# Groundwater Transfer Review Summary Form

Transfer/PA # T- 14371

Application: T-14371

Applicant Name: David and Kaitlyn Braun

Map

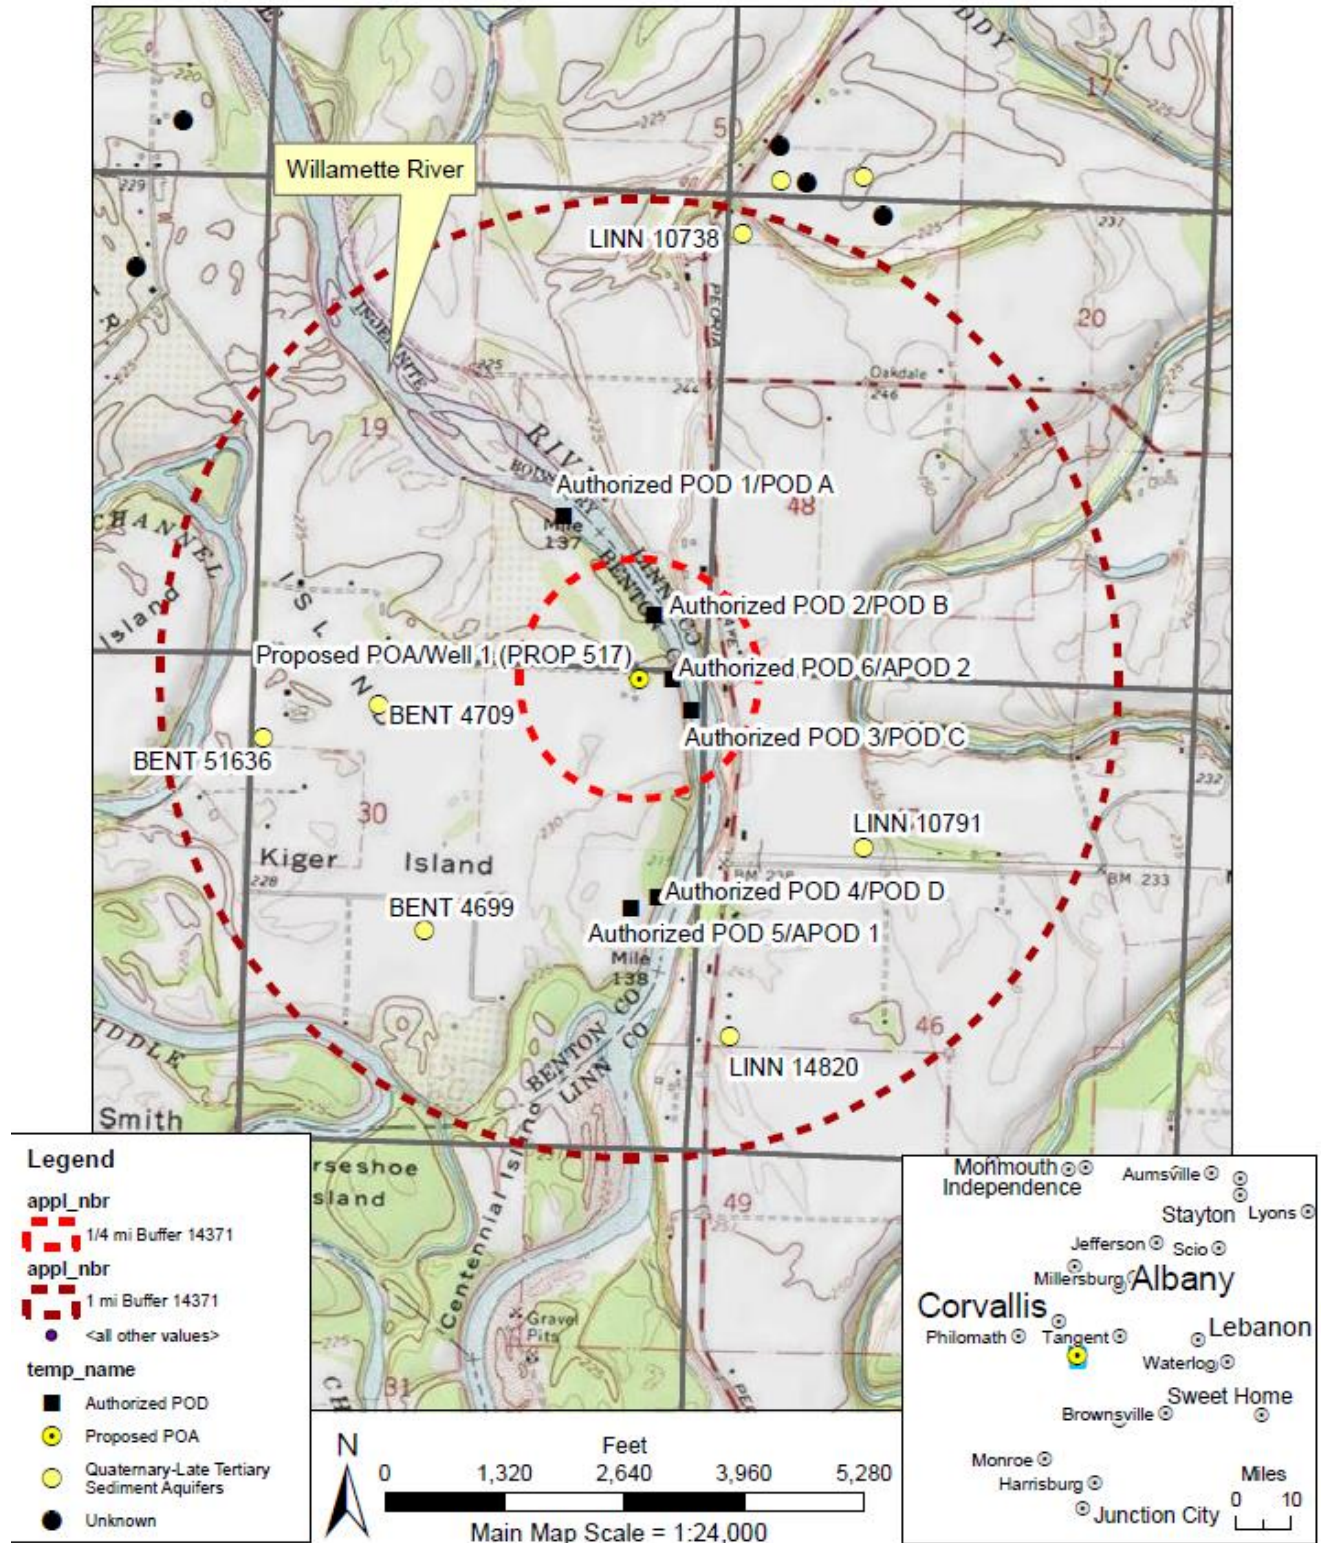
1. Basic description of the changes proposed in this transfer: Applicant proposes to transfer six surface water points of diversion, PODs, authorized under Certificate 97291 to a new well. The PODs are POD A, POD B, POD C, POD D, APOD 1, and APOD 2. The well is Well 1/PROP 517.

4. a) Will this proposed change, at its maximum allowed rate of use, likely result in an increase in interference with **another ground water right**?  
 Yes  No Comments: Interference with nearby irrigation well BENT 4709 will increase as a result of the proposed transfer, since the subject PODs divert directly from surface water and the proposed groundwater POA (Well 1/PROP 517) will produce groundwater near BENT 4709.
